**REVIEW TYPE:** Preliminary Plan of Subdivision

**PROJECT NAME:** Gingery Property

**CASE NO.** 1-00060

**STAFF RECOMMENDATION: Approval of Five (5) Lots Only, Subject to the Following Conditions:**

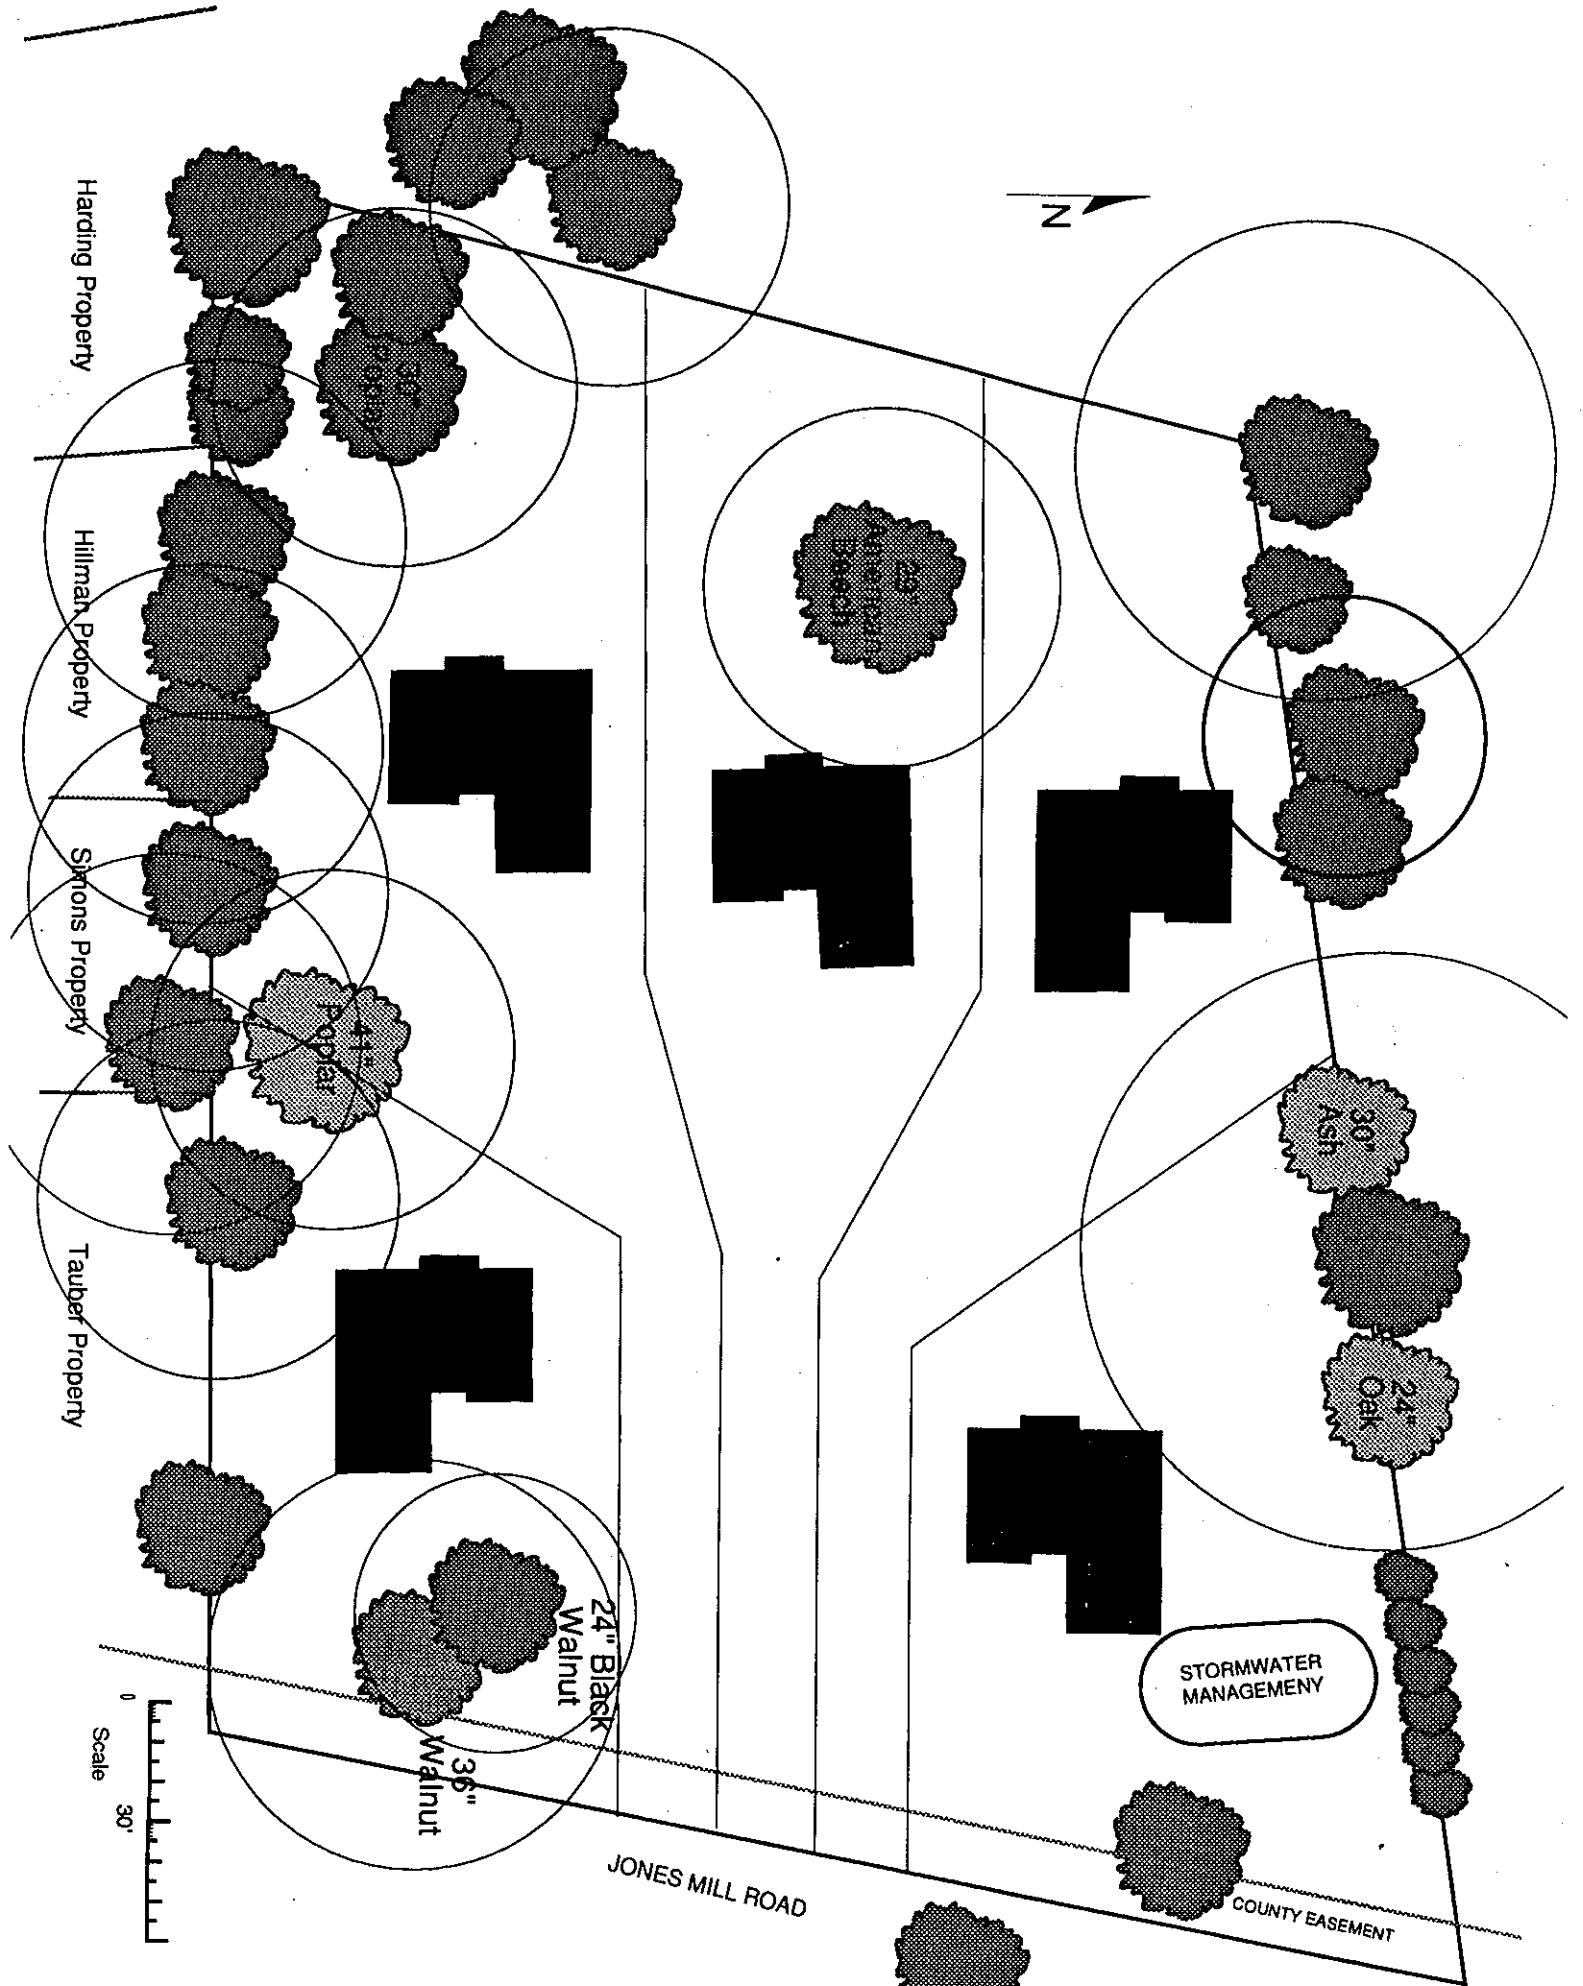
Attached drawing, though not professionally drafted, illustrates the number and areas of CRZ's of significant and specimen trees that could be preserved with a five lot subdivision. If only five houses were proposed on this site, the reduced disturbance for grading of house sites and driveways would potentially save 8 additional trees, 4 of which are 24" dbh or greater. Additionally, the impacts to any of the CRZ area of trees on adjacent properties could be avoided.
